242-244 Beecroft Road, Epping Concept Modification 1 and Detailed Design SSD

State Significant Development Assessment
SSD 8784 MOD 1 and SSD 31576972
August 2023

Subtitle: State Significant Development Assessment SSD-31576972

Figure 31 | Proposed building envelopes Levels 1 to 4 (blue) with approved building footprints in red outline (Source: Applicant’s RTS)

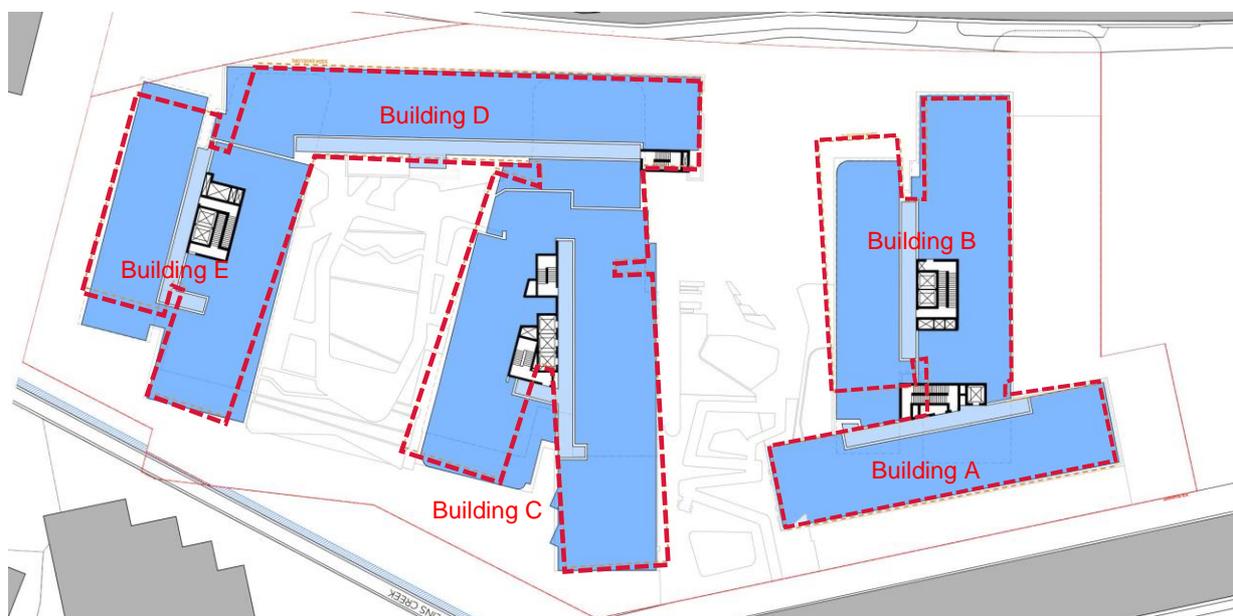
78. The Applicant argued that the amended building envelopes would allow for increased solar access to apartments, ensure compliance with building separation requirements within the ADG and make the buildings easier to build compared to the approved Concept.

79. Council raised concerns that the modified building envelopes would be larger than the approved Concept, resulting in buildings with less modulation and a reduced setback to the north-west corner of the site towards Devlins Creek.

80. In response to Council's concerns, the RtS provided additional justification for the proposed changes to the building envelopes, and it put forward several amendments to address residential amenity.

82. The Department therefore supports the proposed modifications to the building envelopes.

Figure 34 | Building separation – left: Concept approval, right: proposed amendment (Source: Applicant's RTS)

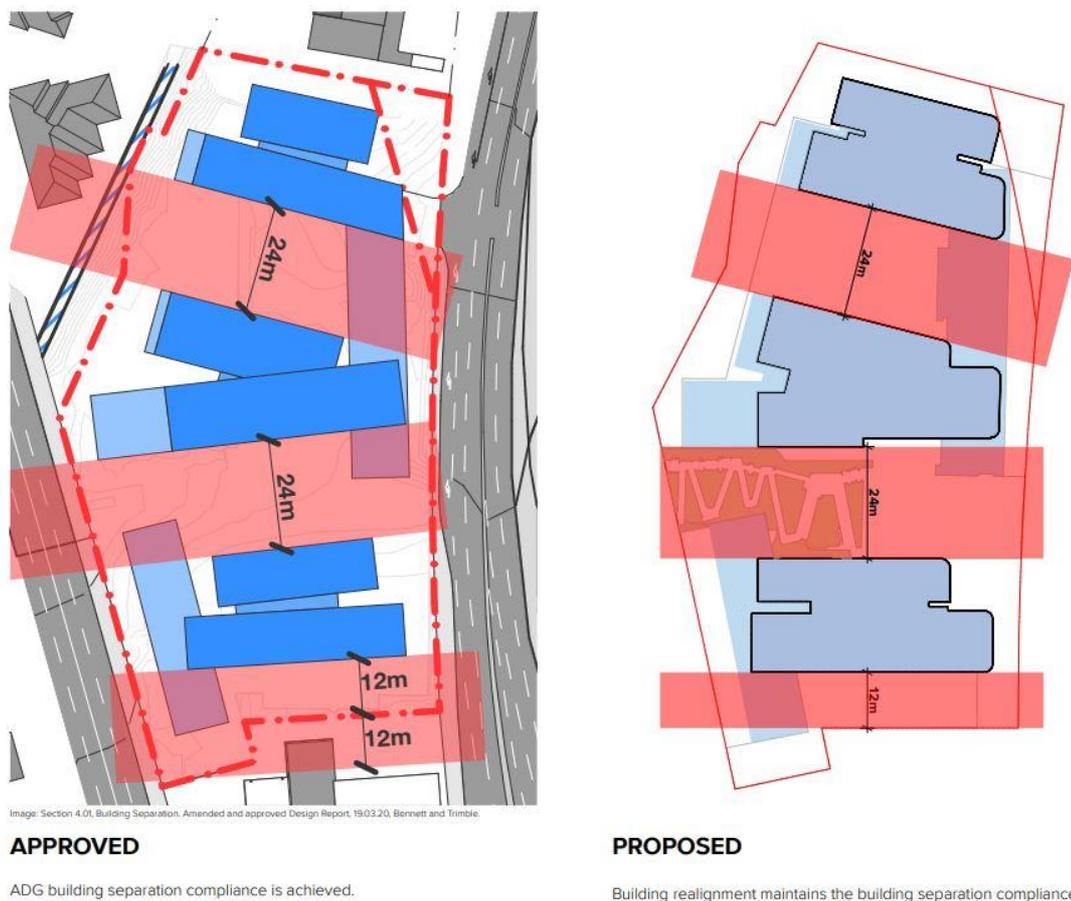
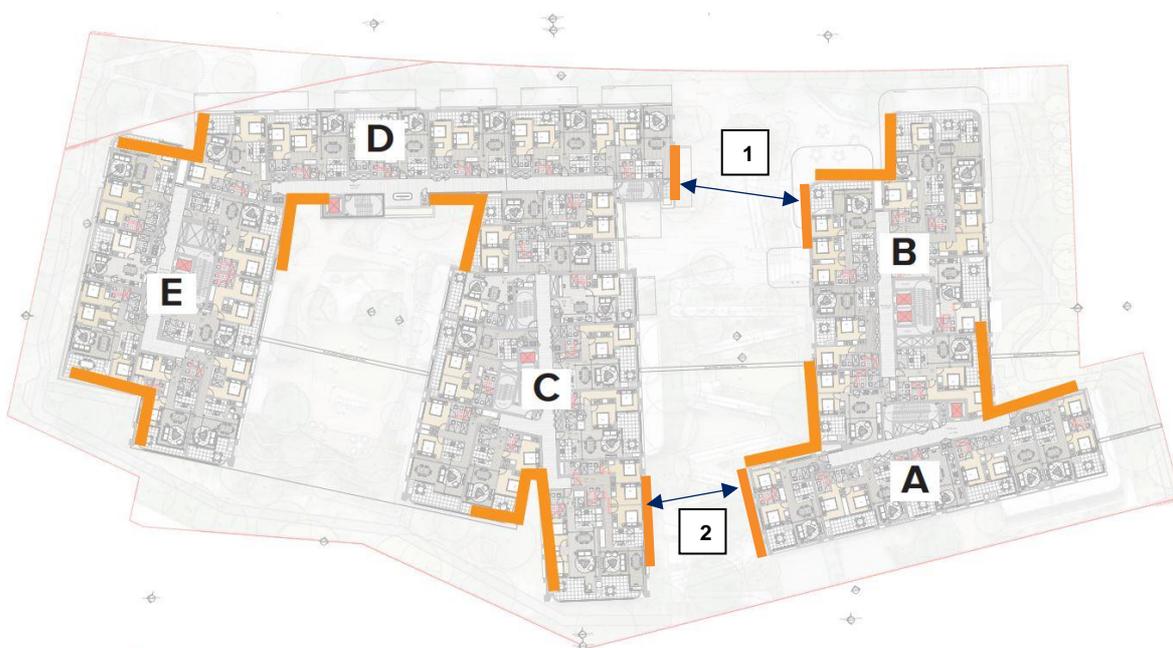
99. However, Council and the SDRP raised concern that several interfaces, corners and junctions of the proposed buildings may provide opportunities for overlooking between living rooms, bedrooms and balconies between apartments. The areas of concern are shown in **Figure 35** below.

100. In response, the Applicant's RTS reviewed the design of each of the corner and junction areas and made changes to windows, columns, solid walls, angled fins, and other architectural devices to avoid potential overlooking. An example of the treatment between the central junction in Building C is shown in **Figure 37** below.

Figure 36 | Proposed privacy treatment between apartments in Building C (Source: Applicant's RTS)

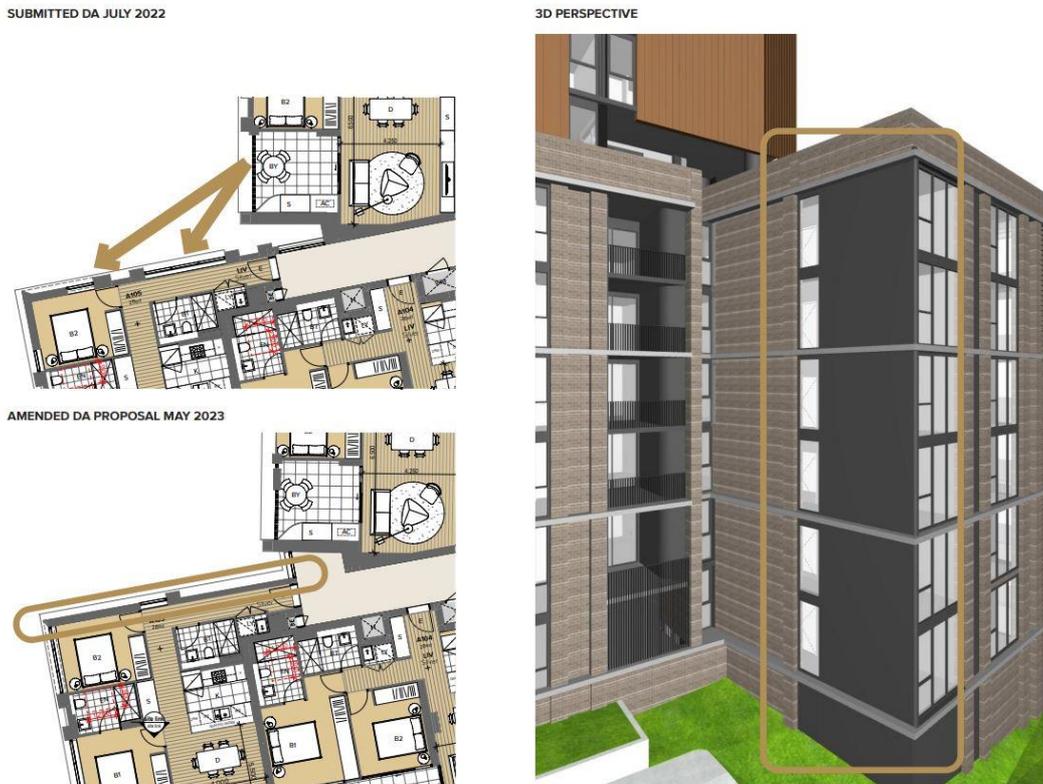
- the amendments, including adjustments to windows, walls and balconies further avoid overlooking opportunities. An example of the amended architectural treatment to avoid overlooking at a junction of Building C is illustrated in **Figure 36** below.

103. The Department therefore concludes the proposal would provide an acceptable level of visual privacy for its future residents.

Figure 38 | Proposed ground floor of Building A (Source: Applicant's RTS)

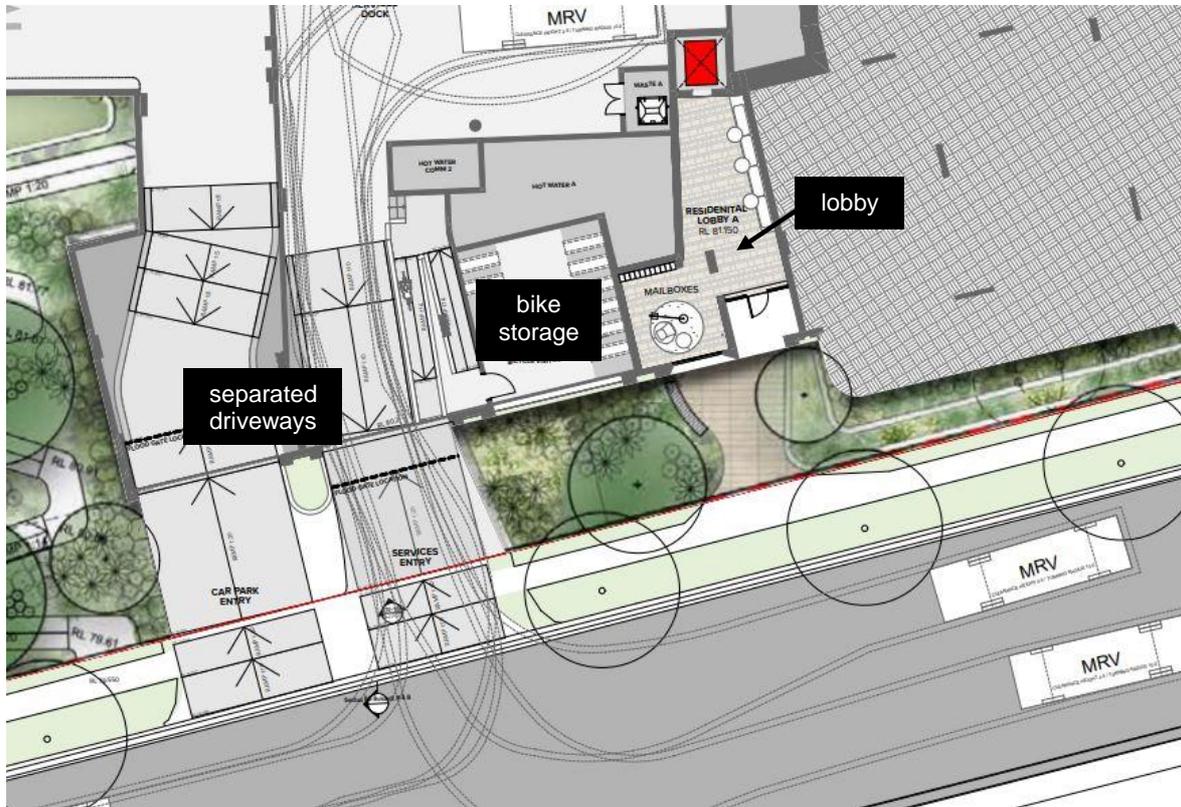
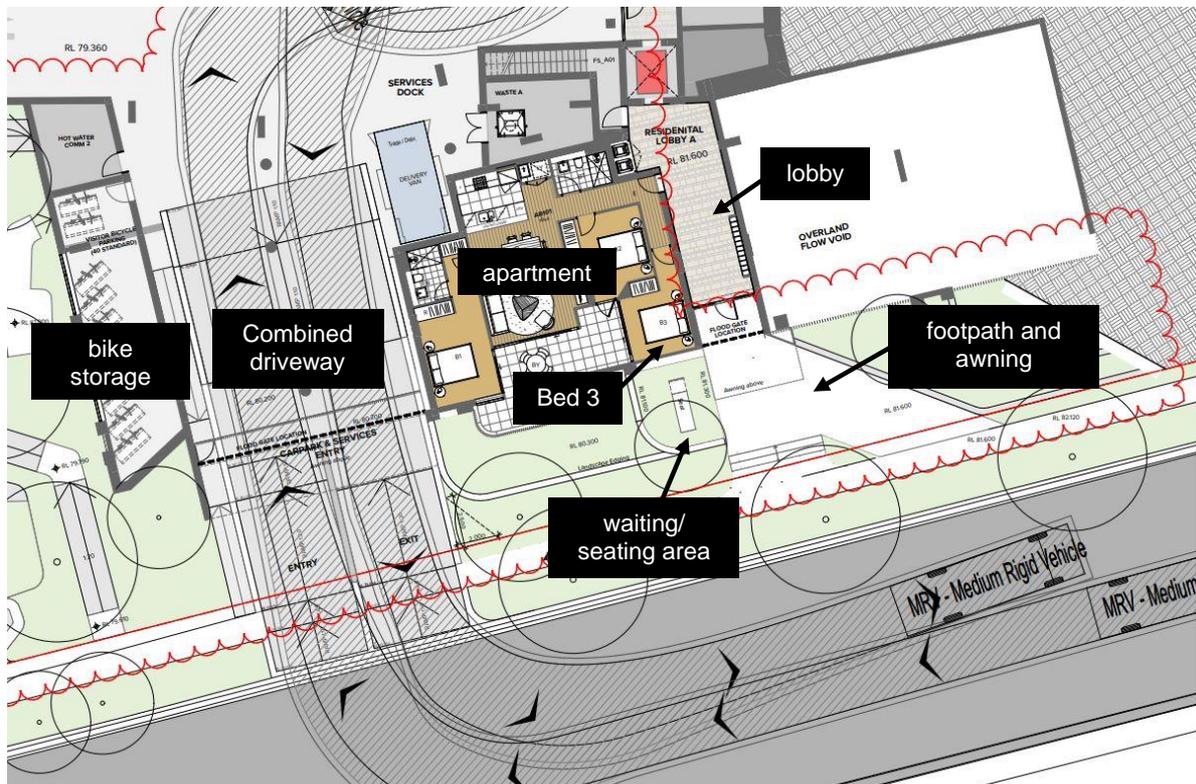
105. Council raised concern that the Ray Road frontage of the proposal lacked activation due to the ground plane being dominated by a driveway and services. Council recommended amendments including locating at least one apartment along the Ray Road frontage of the building, relocating the bicycle storage area as well as providing a more generous building lobby and entrance area.

107. Council reviewed the RtS and objected to the reduced size and frontage of the lobby and the addition of the apartment, despite its earlier request for one to be included. In particular, Council said the revised lobby provided little to no visual interest or activation of the frontage. Council also said the proposed apartment would have poor acoustic and visual privacy due to its location next to the driveway, building entrance and basement.

109. While the Department accepts the addition of an apartment along the Ray Road frontage improves activation and passive surveillance, concern is raised about the reduced entrance lobby to Building A as it would result in a compromised street address to Ray Road and poor amenity within the lobby area.

110. The Department notes a comparison of the amended proposal, and the original proposal shows that the area of the entrance lobby has been reduced to incorporate a third bedroom for the proposed ground floor apartment. The Department considers the design and location of this bedroom unreasonably reduces the width of the building entrance and results in poor amenity due to its direct interface with a proposed outdoor waiting/seating area adjacent to the lobby. (compare **Figure 37** and **Figure 38**).

106. In response, the Applicant amended the proposed entrance to Building A and included a three-bedroom apartment on the ground floor. The Applicant also reduced the width of the driveway and relocated the bicycle storage area (see **Figures 37 and 38**).

Figure 40 | Rooftop communal open spaces with plant rooms and roof of Building C and Building E shaded red (Source: Applicant's RTS)

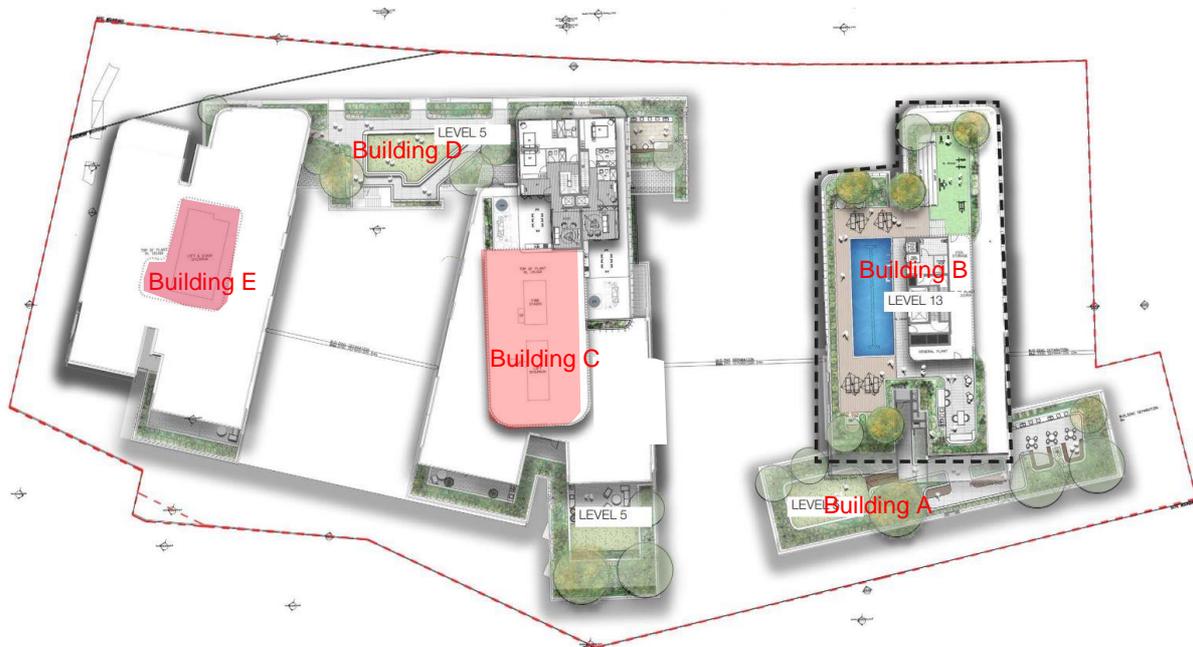
118. Council also recommended that previously indicated communal open space on the rooftops of Buildings C and E in the indicative scheme accompanying the Concept Approval should be included to increase communal open space with good solar access.

119. Council also raised concerns about access to rooftop communal open space from each of the buildings.
120. The SDRP notes solar access to the primary ground floor open space would be challenging due to the shadows cast from the proposed buildings. The SDRP recommended careful consideration of the planting species for the space, given its located in a shaded area above a basement.

121. In response to Council's concerns and the SDRP advice, the RtS provided additional information on:
- access arrangements from lobbies to rooftop open spaces

- itemised the planting selection made by the landscape architects
 - demonstration that each apartment can access each of the rooftop open spaces.
122. The RtS was also supported by additional shadow diagrams. The shadow diagrams illustrate that the ground floor communal open space will not receive two hours solar access at midwinter. The Applicant argues that the reduced solar access for the ground floor communal open space would be compensated by the rooftop spaces having very good solar access.

Figure 42 | Perspective view of ground level private open space between Buildings C and E (Source: Applicant's RTS)

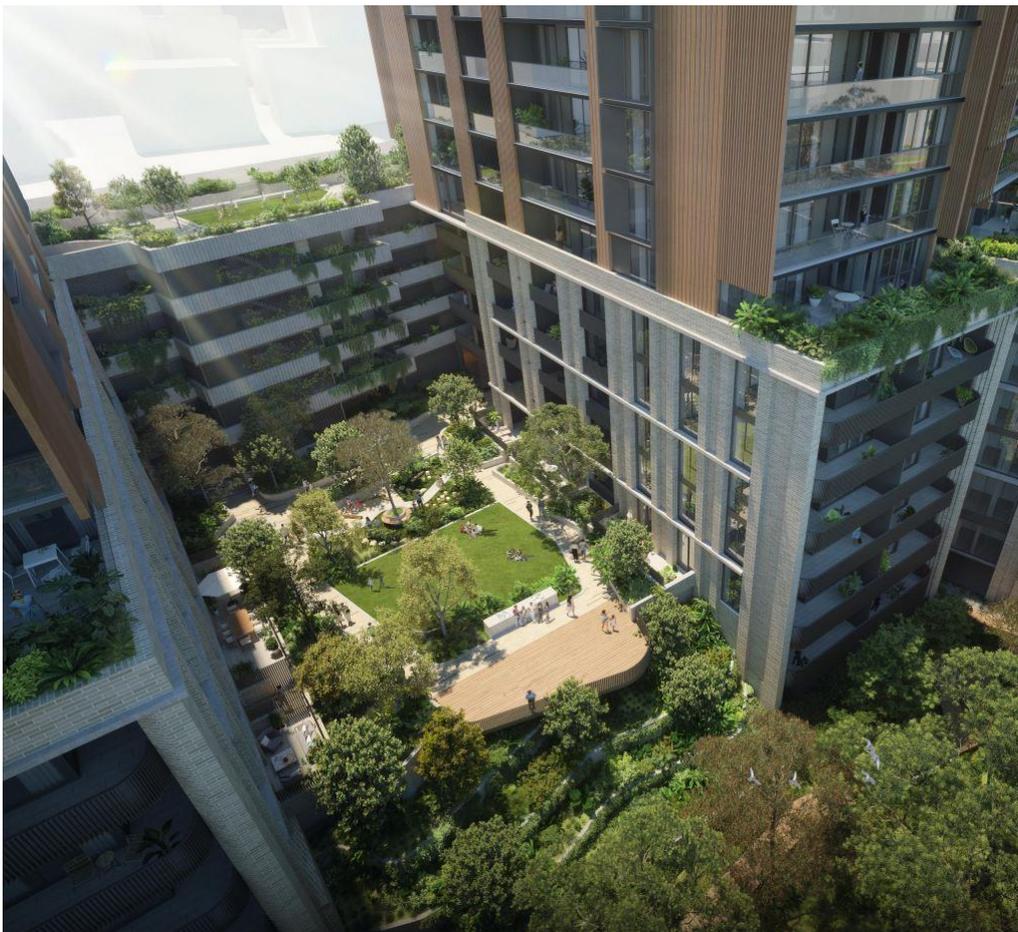
123. The Department acknowledges Council's recommendation to provide more communal open space on the rooftops with better solar access. The Department also notes that the Concept Approval indicated the rooftops of all buildings were identified as opportunities for landscaping. However, the Department notes the rooftops of Building C and Building E are small and are directly located above plant rooms and are not best suited to accommodate additional communal open spaces. Future residents from Building C and E would also have access to the roof top open space above the connecting podium at Building D and at Level 5 of Building C and the proposed ground level communal open space. **(Figure 42)**

Figure 43 | Through-site link design at lodgement (left) and as proposed at RTS stage (right) (Source: Applicant's RTS)

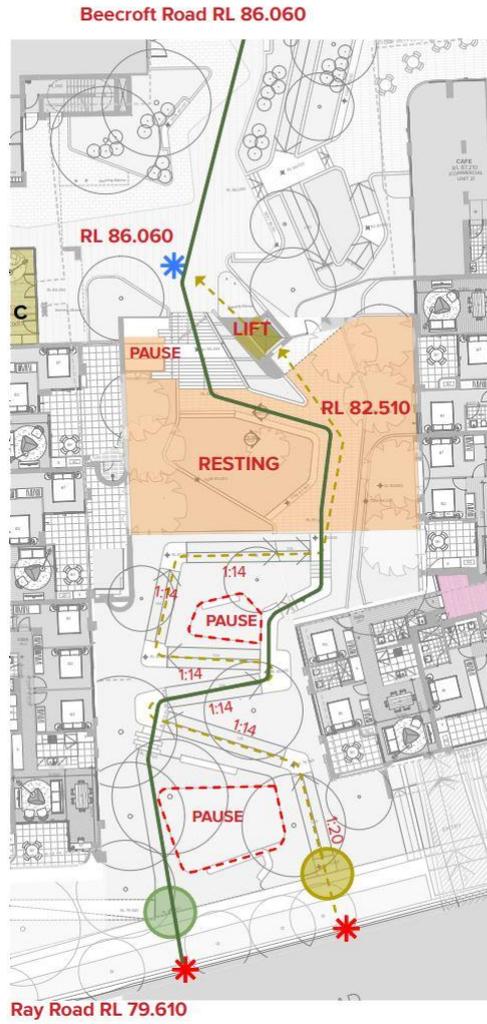
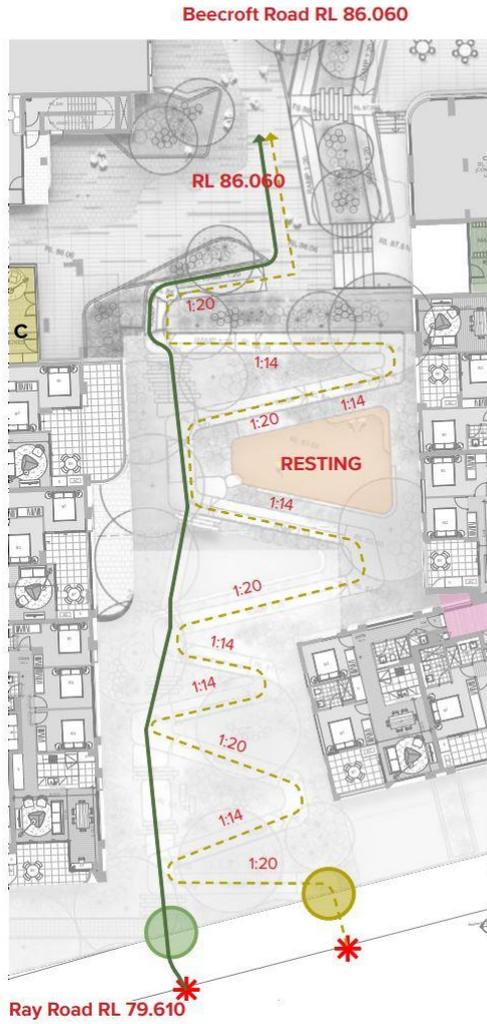
- demonstrate adequate privacy/amenity can be provided to the apartments facing the through-site link.
131. In response, the Applicant amended the design of the through site link (**Figure 43**) to include:

- adding a lift in the centre of the link to provide an option to negotiate the gradient and provide an overall compliant accessible path
 - breaking up the main pedestrian ramp into four sections rather than the original 10 sections to ensure the total rise complies with access standards and is less convoluted and visually dominating, as well as provide more soft landscaping and deep soil planting

- relocating a staircase and planter beds towards the Beecroft Road end of the link to provide greater visibility into the link from the public domain.

132. The Department considers the amended design of the through site link is satisfactory because:

Figure 48 | Proposed rows of tree planting along Beecroft Road (Source: Applicant's RTS)

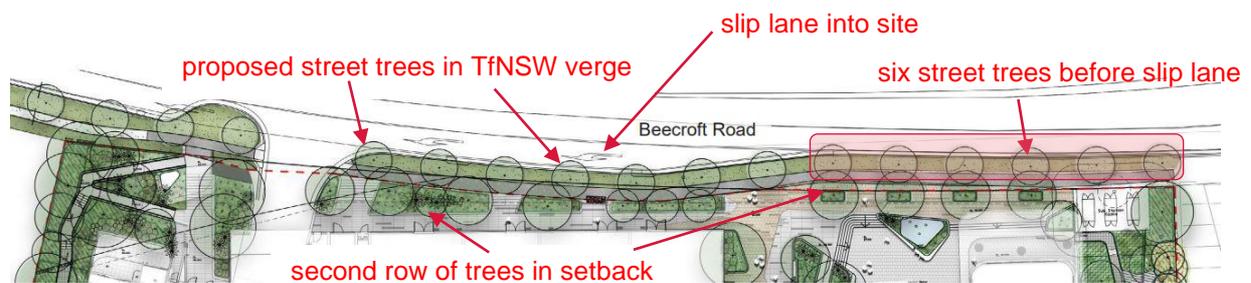
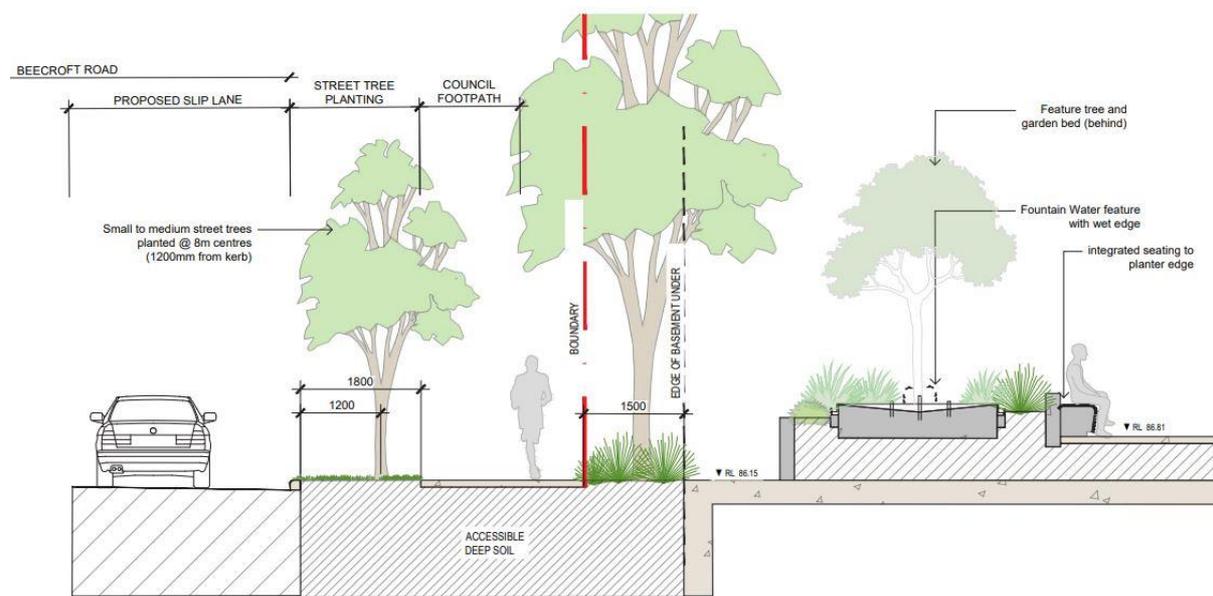
143. Condition B2 of the Concept Approval requires the Applicant to consult with Transport for NSW to confirm the opportunity to plant street trees along the Beecroft Road frontage of the site (Figures 48 and 49).
144. Council advised that larger trees should be planted in the front setback zone should the street tree planting identified could not be supported by Transport for NSW. Council also advised the basement setback should be increased in this scenario to provide larger trees to increase shade and provide a visual buffer to the development.

145. In response to the requirement of Condition B2 of the Concept Approval and Council's concerns, the Applicant consulted further with TfNSW on the proposed street trees along Beecroft Road.
146. TfNSW confirmed that it supports the proposed street tree planting outside the clear zone for through traffic on Beecroft Road (located within the slip lane).
147. TfNSW requested that the street tree planting zones be designed in accordance with TfNSW Landscape Guidelines. This includes species selection to ensure the trees are capable of bending or snapping in the event of collision.

148. The Department notes the proposed trees fronting the slip lane frontage are acceptable to TfNSW. The Department notes that six trees are outside this area and would be deleted. However, the Department is satisfied the deletion of these trees would not materially affect the landscaped presentation of the development along Beecroft Road noting a second row of trees are proposed within the site's setback area (**Figure 49**).
149. The Department therefore considers the RtS has satisfied the requirement of Condition B2 and the proposed tree planting along Beecroft Road frontage of the site is acceptable.
